Informal meeting on Code of Practice for Packing of Cargo Transport Units

Updates to the CTU Code

Blocking and rear end securing

Submitted by ETS Consulting

Figure 7.6 General layout of fence battens for door protection in a CTU

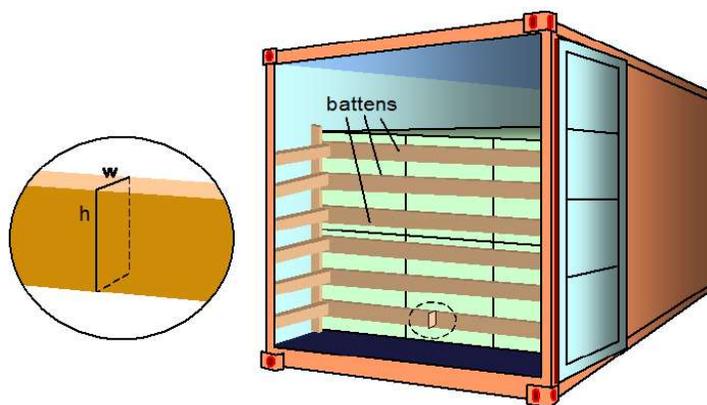
The principle of securing the load against the corner posts of the container to prevent longitudinal displacements, as shown in 2.3.4, figure 7.6, cannot be applied to the container structures currently used and should be reformulated.

- 2.3.4 Transverse battens in a CTU, intended to restrain a block of packages in front of the door or at intermediate positions within the CTU, should be sufficiently dimensioned in their cross section, in order to withstand the expected longitudinal forces from the cargo (see figure 7.6). ~~The ends of such battens may be forced into solid corrugations of the side walls of the CTU. However, preference should be given to brace them against the frame structure, such as bottom or top rails or corner posts.~~ Such battens act as beams, which are fixed at their ends and loaded homogeneously over their entire length of about 2.4 metres. Their bending strength is decisive for the force that can be resisted. The required number of such battens together with their dimensions may be identified by calculations, which is shown in appendix 4 to this annex.

Wherever possible such battens should be braced against the frame structure, such as bottom or top rails or corner posts. While it is recognised that this type of bracing is not possible on all types of CTU, any that has a shoring slot built into the rear frame can accommodate this bracing technique. Alternative bracing can be achieved by forcing the battens into the solid corrugations of the side walls of the CTU, employing a modular lashing

system as described in subsection 2.4.19 of this annex or the use of friction increasing material.

Figure 7.32 Blocking in a strong boundary CTU

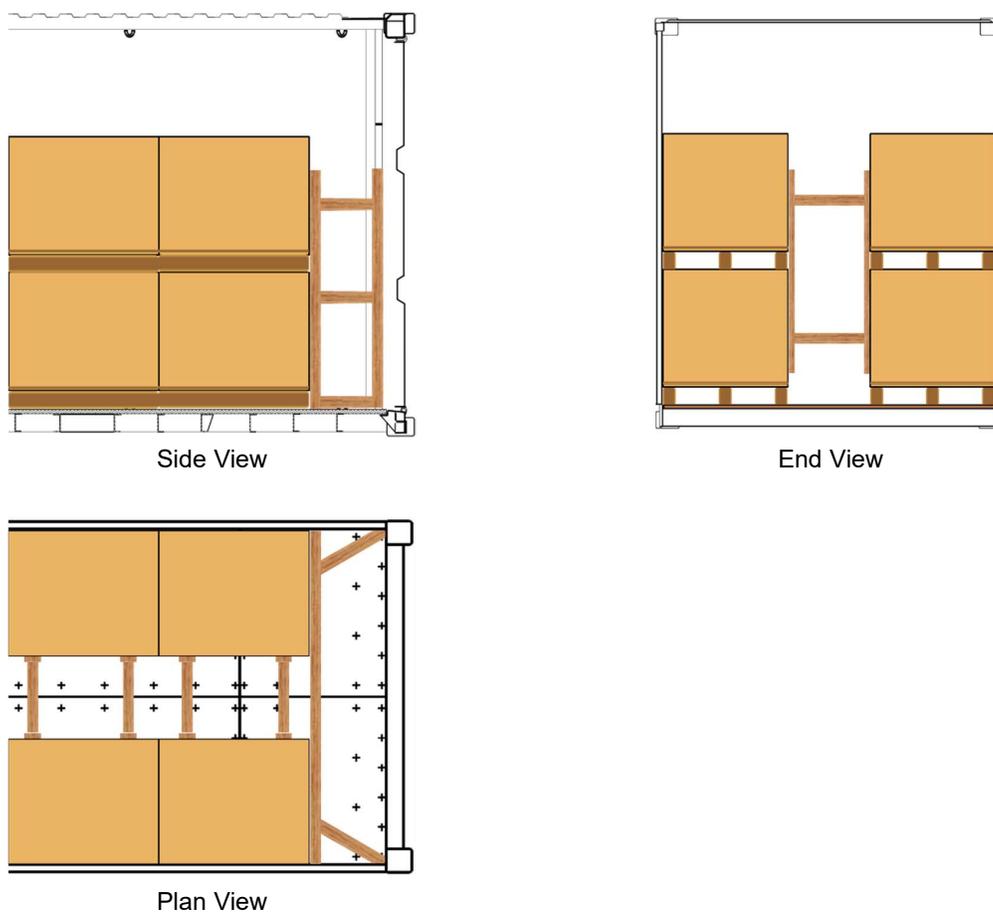
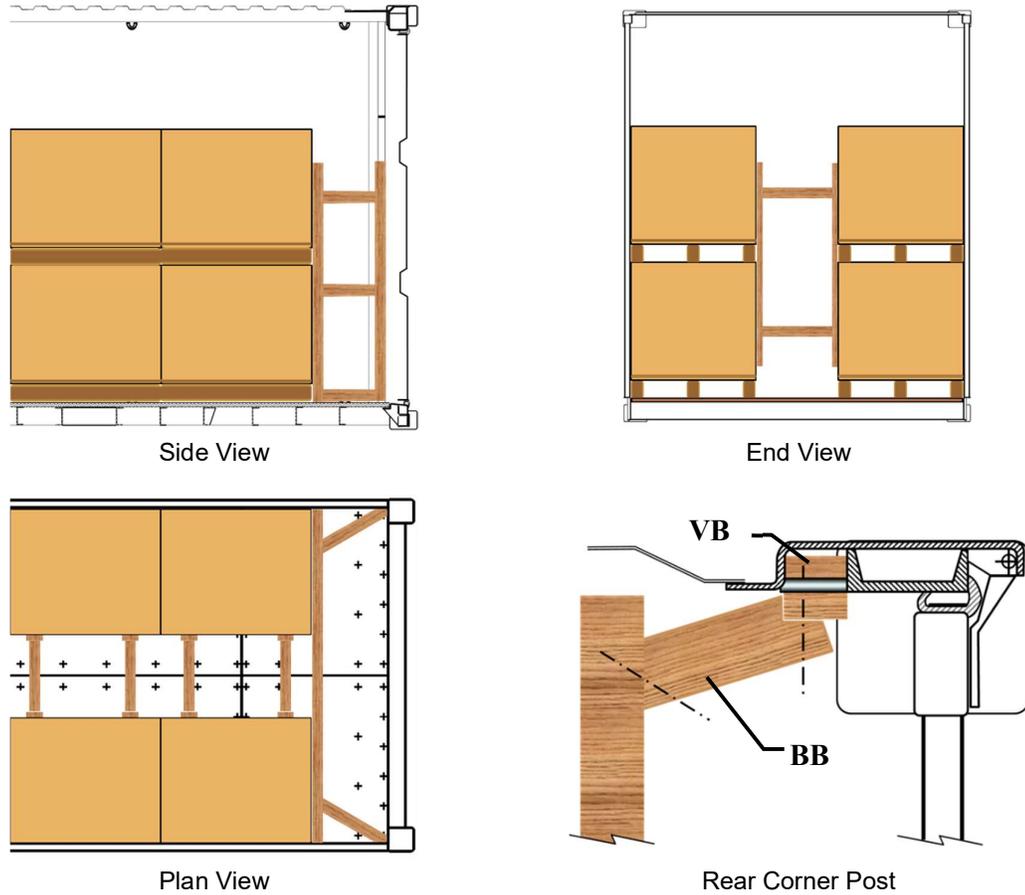
The example of securing a load to the corner posts of the container door opening shown in figure 7.32 is not correct, as the corner posts do not protrude beyond the side walls of the container.

4.2.4 Critical situations may arise, e.g. e.g., with a fully packed freight container in road transport, where longitudinal securing should be able to withstand an acceleration of 0.8 g. The longitudinal wall resistance factor of 0.4 should be combined with a friction factor of at least

0.4 for satisfying the securing balance. If a balance cannot be satisfied, the mass of cargo should be reduced, or the longitudinal forces transferred to the main structure of the container. The latter can be achieved by intermediate transverse fences of timber battens (see subsection 2.3.4 of this annex) or by other suitable means (see figure 7.32). When bracing against the rear corner frames, vertical timber battens (VB) should be inserted into the shoring slots between the slot bars and the bracing battens (BB) fitted against this. Where required nails or other fixings can be used to stabilise the bracing battens.

Another option is the use of friction increasing material.
